North Liberty Planning Commission
Tuesday, July 7, 2020, 6:30 PM

To **City of North Liberty Planning Commission**
From **Ryan Rusnak, AICP**
Date **July 7, 2020**
Re **Request of Linn County Rural Electric Cooperative Association to approve a Site Plan at the south 280 feet of Lot 104 of Inter-City Industrial Park, Part Two, located at 835 240th Street.**

Project Name: Linn County REC Vehicle Storage

SITE PLAN

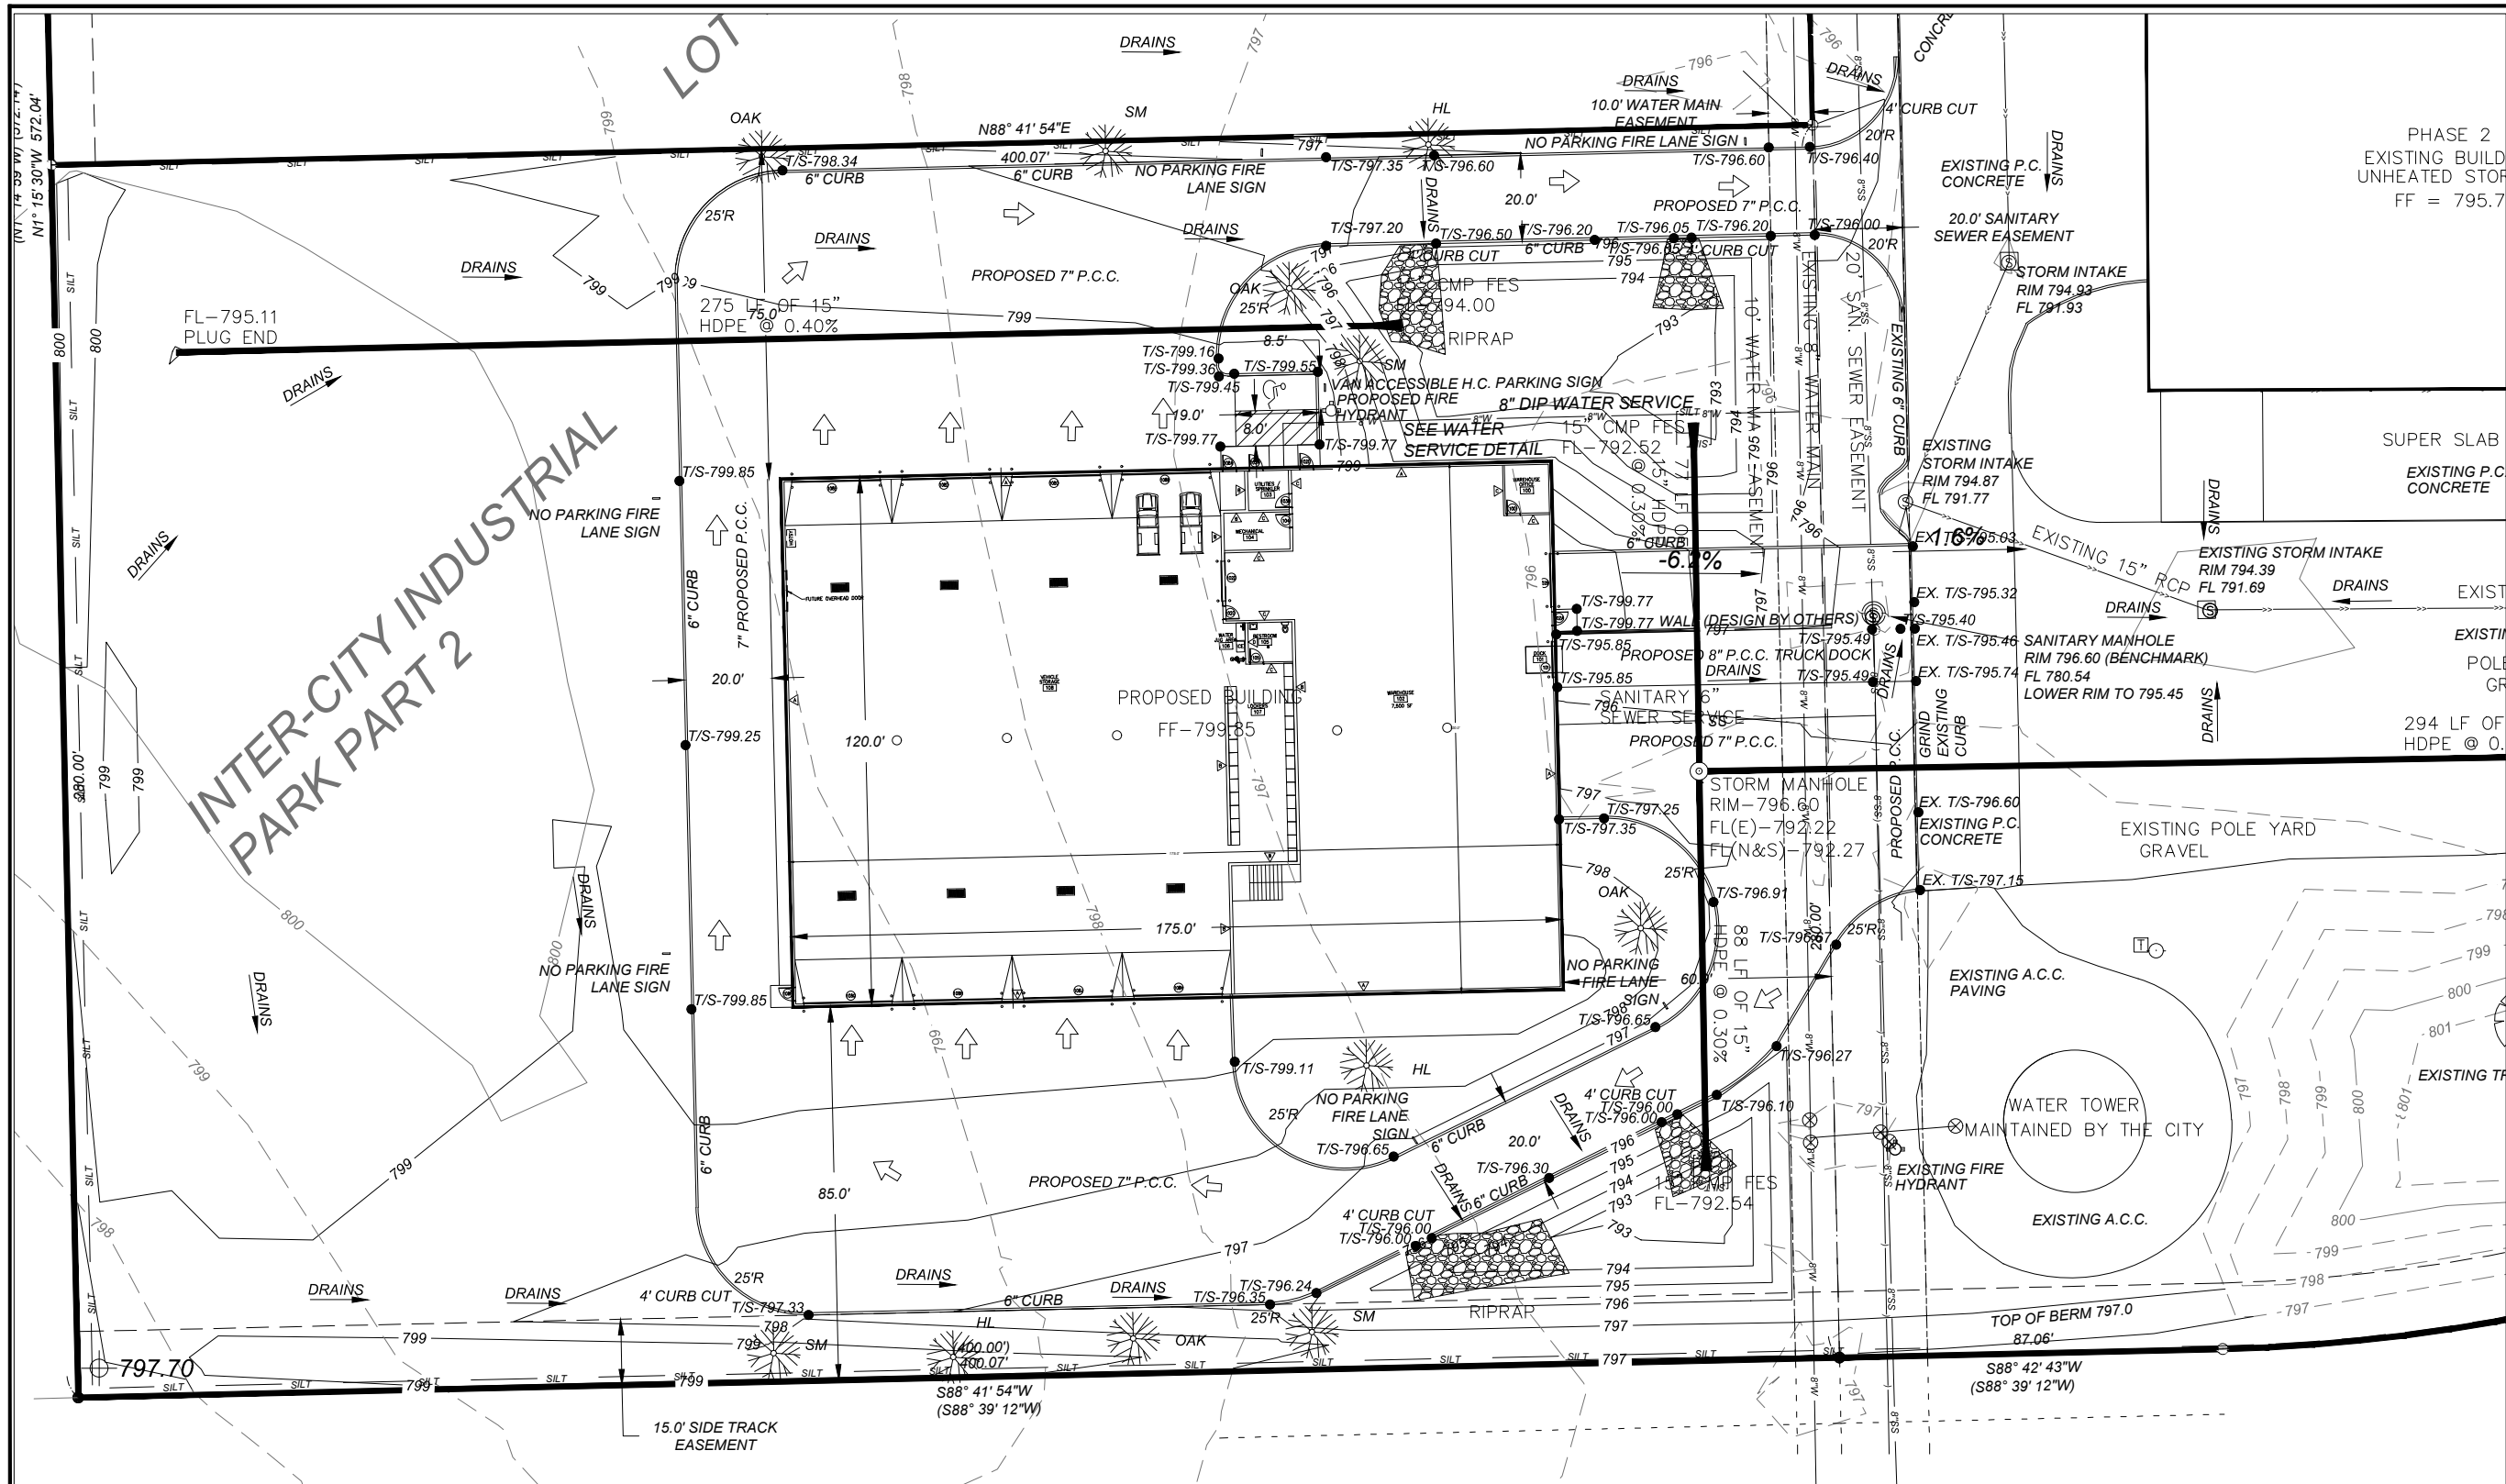
(12) *Location and type of all plants, grass, trees, or ground cover to be used in the landscape. Landscaping shall be illustrated in elevation and color perspective with the size and exact names of plants, shrubs, or trees to be planted clearly indicated.*
This information has been provided on sheet 3 of the site plan. A color perspective has not been provided.

Although zoned I-1, the property south of the subject property is designated residential (yellow) and Commercial and residential (yellow and red crosshatched) on the Future Land Use Map. Therefore, staff is recommending additional landscaping along the south property to mitigate a potential less intense use.

1)	Compliant	IFC:503.1.1	Building has an approved fire apparatus access road within 150' (200' if fully sprinklered with NFPA 13 sprinkler system) of any exterior portion of the structure?
2a)	Not Shown	IFC:D104.1	Buildings exceeding three stories or 30 feet in height have at least two accesses for each structure?
2b)	N/A	IFC:D104.2	Buildings exceeding 62,000 square feet or exceeding 124,000 square feet (with approved sprinkler system) shall be provided with two separate and approved fire apparatus access roads?
2c)	N/A	IFC:D106.1	Multi-family residential projects having more than 100 dwellings units are provided with two separate and approved fire apparatus access roads?
2d)	N/A	IFC:D107.1	Developments of one- or two-family dwellings where the number of dwelling units exceed 30 are provided with two separate and approved fire apparatus access roads?
2e)	N/A	IFC:D104.3 IFC:D107.1	When two separate and approved fire apparatus access roads are required, they are placed a distance equal to not less than one-half the length of the maximum overall diagonal dimension of the property or area to be served, measured in a straight line?

4)	Not Shown	IFC:D102.1	Access roads are designed to support fire apparatus weighting at least 75,000 lbs.?
5)	Compliant	IFC:D103.2	Access roads does not exceed 10% grade (Elevation / Distance)?

12)	Compliant		Water mains and pipe sizes are detailed on the site plan?
13)	Non-Compliant		Fire Hydrants shown on the site plan?
14)	N/A	SUDAS:E.3.a	Fire Hydrants located correctly from intersections (25 Feet of each intersection)?

20)	Not Shown	IFC:507.5.5	Are hydrants unobstructed (3 Ft. Clear space required around fire hydrant)?
21)	N/A	IFC:507.5.6	Physical protection for fire hydrants subject to impact by motor vehicle?

#2a	Building Height was not provided. If building height exceeds 30 feet, aerial access requirements will apply.
#4	Note on plans: Fire Department apparatus road/drive around building is designed to support fire apparatus weight at least 75,000 lbs.

#9	No Parking Fire Lane signage spacing, and location will be provided by fire department.
#13/#20	<p>Fire Hydrants shall be provided on the site plan as required by the building construction and square footage for the fire flow as indicated in the 2018 IFC Table B105.1(2) and spaced according to 2018 IFC Table C102.1.</p> <p>Provide Building Construction Type to accurately determine fire flow and fire hydrant requirements. Type IIB & IIIB, sprinklered, would require 1500 gpm fire flow, 1 hydrant. Type VB, sprinklered, would require 2,000 gpm fire flow, 2 fire hydrants.</p> <p>The existing fire hydrant next to the water tower will not be used in the count for required fire hydrants as it would be difficult to utilize this fire hydrant.</p> <p>Fire hydrant shall be protected by curb or bollards. Shall have 3' of clear space from obstructions and from parking and be visible.</p> <p>Fire hydrant to be located with 100 feet of sprinkler Fire Department Connection.</p>

1. That additional landscaping be placed along the south property line to mitigate a potentially use intense future use; and
2. That the site plan/architectural rendering be amended to incorporate the review comments from the Fire Marshal prior to City Council’s consideration of the site plan.

EXTERIOR ELEVATIONS

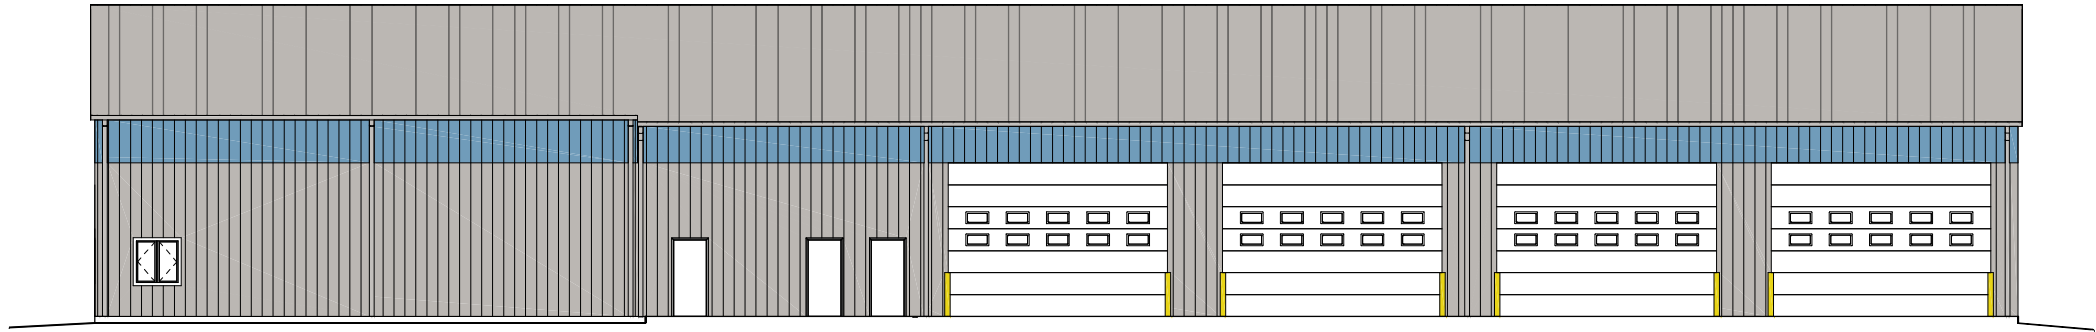
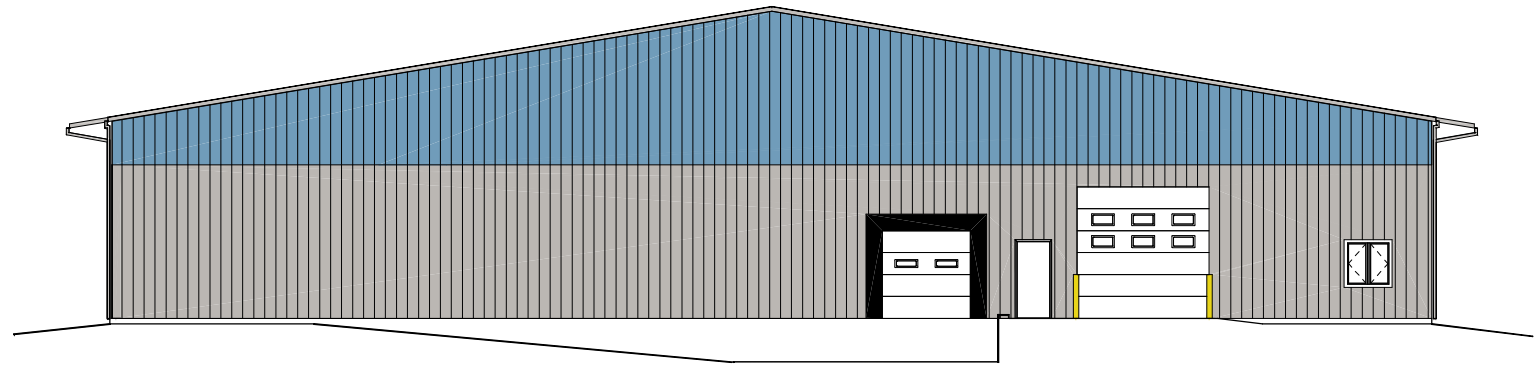
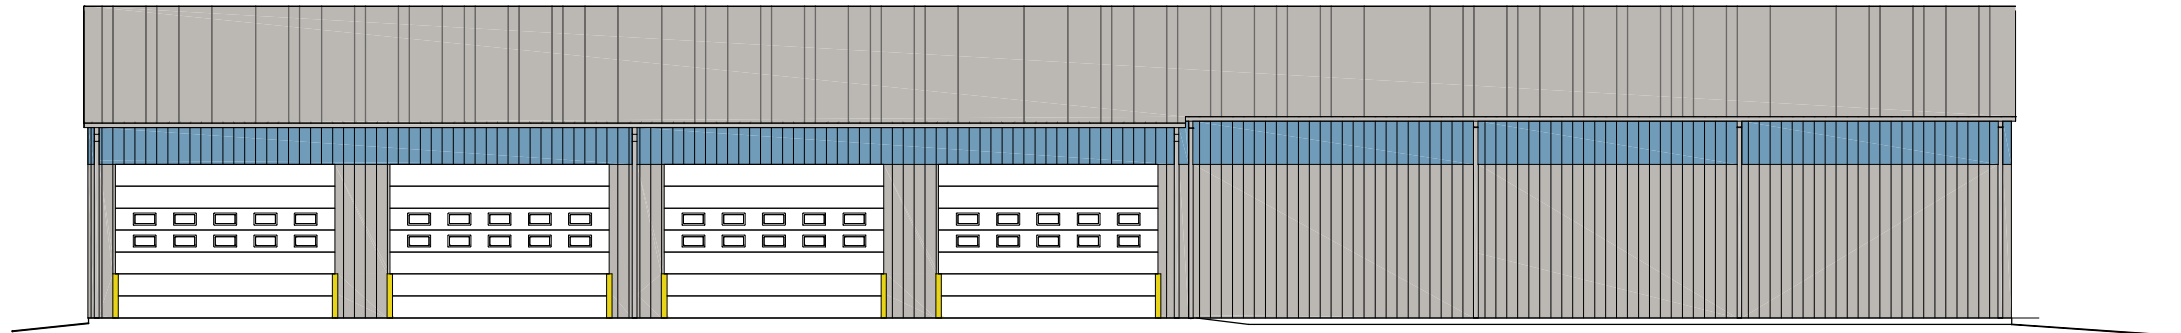
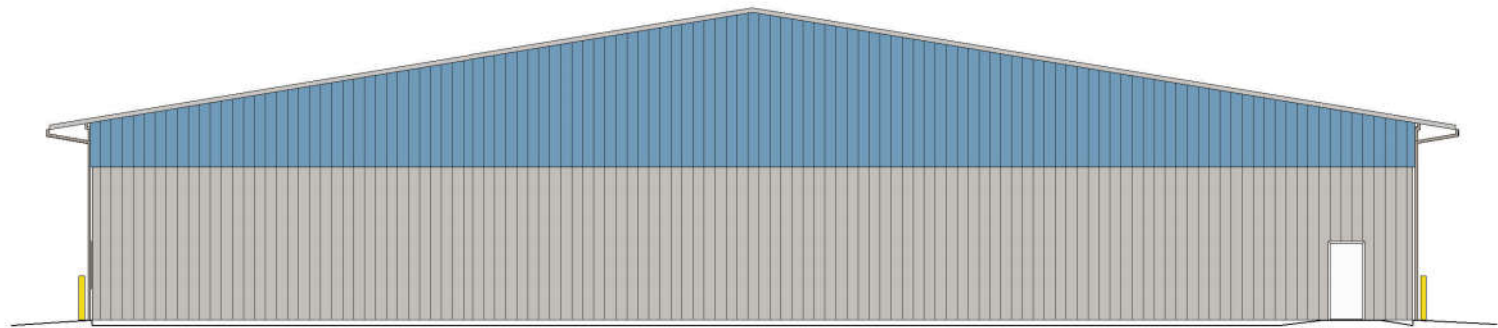
This information has been provided on the cover sheet of the site plan and on the provided architectural rendering. This is a metal industrial building and is utilitarian in design. City design standards require color schemes based on earth tones or other compatible colors. The primary building color is grey and has a blue accent color. This is consistent with the color of the building adjacent to 240th Street.

The Zoning Ordinance defines the primary face of a building as “...the wall of a building on a street or right-of-way, excluding any appurtenances such as projecting fins, columns, pilaster, canopies, marquees, showcases or decorations” Since this building does not front on 240th Street, the 25% masonry requirement is not required.

#22/#23	<p>Site plans indicates sprinkler room, but it is unclear if the building is being sprinklered. Occupancy classification for building was not provided. An automatic sprinkler system shall be provided throughout all buildings containing a Group S-1 occupancy where one of the following conditions exists: fire area exceeds 12,000 square feet or a Group S-1 fire area used for the storage of commercial motor vehicles where the fire area exceeds 5,000 square feet.</p> <p>*Post Indicating Valve (PIV) is noted on the service detail, assuming for the automatic sprinkler system. We typically do not approve the use of PIV since exterior access to the sprinkler room is required.</p>
